**STAFF REPORT
ITEM NO. A.**

ADDRESS: 1014 Rock

COA REQUEST: Roof modifications on main house and on garage building, replace front doors, replace porch posts, addition of shutters and iron fence

Proposed front elevation

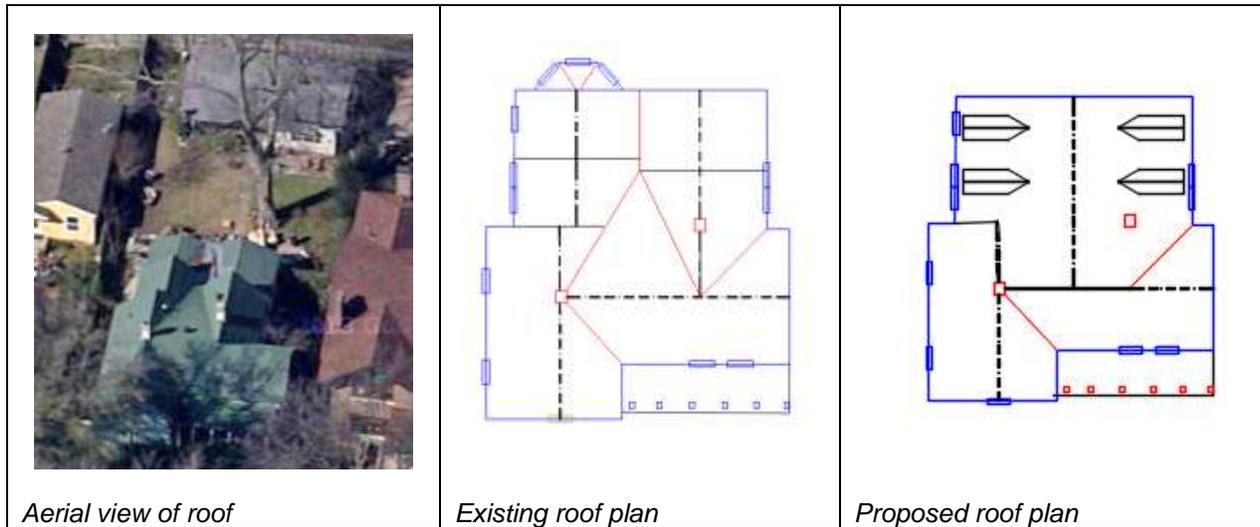
The owners' proposal is to keep the outside pitch of the older additions (12/12) and to extend them skyward to the center of the house until they meet. This will remove a portion of the problem. However, this will affect the front elevation of the house by introducing the top of the gable end which will be almost five feet above the ridge line of the house. They are proposing to put siding in the small gable end and match the soffit and fascia details of the original house. On the newest addition to the house, the shorter section with one bay window, these side walls will be raised to match the older walls and the roof will be raised to match the proposed roof adjacent to the front of the house. There are also four dormers proposed to be added on the side elevations of the house. In elevational view, the ridgeline of the dormers are visible over the ridgeline of the original house. However, when standing on the street, the dormers will

probably not be visible. The dormers would be visible from the street when viewing the house from an angle. Currently, the house does not have any dormers.

The roof modifications would change the rear façade of the house making it substantially higher. The proposal is to remove the existing door and windows and replace with two sets of patio doors. A double window would be added to the second floor and an attic vent.

This roof modification would solve the water issue but the house would lose some of the visual history of the multiple additions to the rear.

In summary, the roof on the main house is obviously a problem. The proposed changes could be appropriate. Staff is concerned about the visibility of the dormers and the proposed ridge of the rear roof being visible from the front of the house.

On the main house, Staff believes that the removal of the dormers will lessen the mass and bulk of the rear additions to the house. It would still be better if the pitch of the roof in the back was adjusted so that the ridge of the new roof would be at the same height as the original ridge of the house. This would make the addition not be visible from the front of the house.

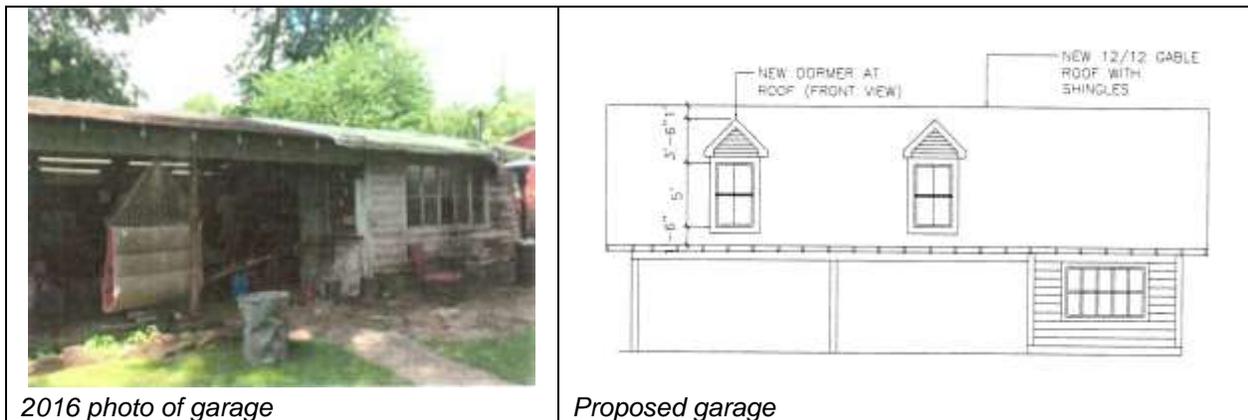
The proposal from the owner is to remove the low pitched roof (approximately 4/12) and to replace it with a 12/12 roof which would add storage space over the garage. A stair would be placed on the north side of the structure for entry. Dormers would be added to the roof facing the house. This would make this garage a one and one-half story structure. In the area of

influence, there are two one story garages, and one two story in addition to the subject property. The two story garage carriage house at 1001 Cumberland was approved and received a COA in 1999. Overall in the district, there are 18 garages placed along the alley and eight other garages in rear yards. 4 of the total of 26 are two story or 15% of the total. When referencing the scaled drawings that were presented to the Commission, the garage is noticeably wider than the house. The scale and massing of a two story equivalent of a three car garage is too large.

This garage is not visible from the street, however with the proposed changes, it would be. The garage has a significant enough roof pitch to shed water as it exists today.

Staff does not believe that the changes to the roof of the garage are appropriate to the area of influence. The majority of the outbuildings in that area, as well as the district, is one-story and if built, the garage would be much more visible than it is now.

Staff believes that the 8/12 pitch roof on the garage is more appropriate. This will lessen the scale and not overpower the site.

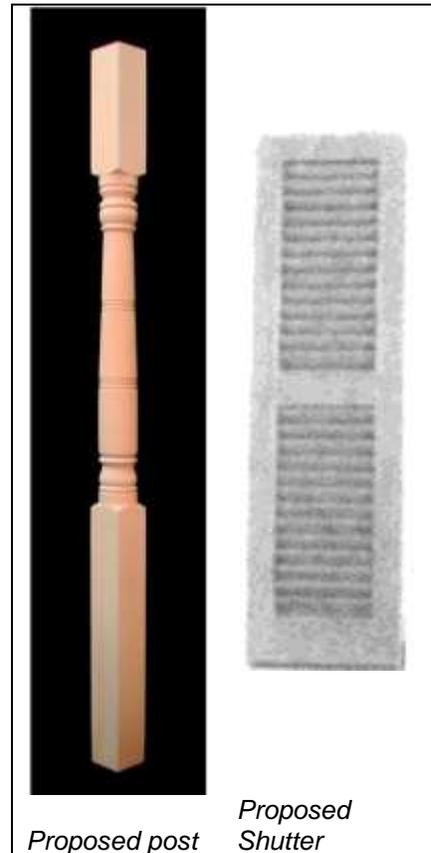
The proposal is to replace both front doors with a matching pair. The door selected is a JELD-WEN Steel Glass panel exterior door with $\frac{3}{4}$ window on the top and two panels below. Currently, there are mismatched doors, one 15 lite French door and one with half glass on the top which are not historic on the house. This ratio of glass and solid on the proposed door is appropriate for this Folk Victorian house.

Staff believes that the proposed front doors are an appropriate choice for the structure.
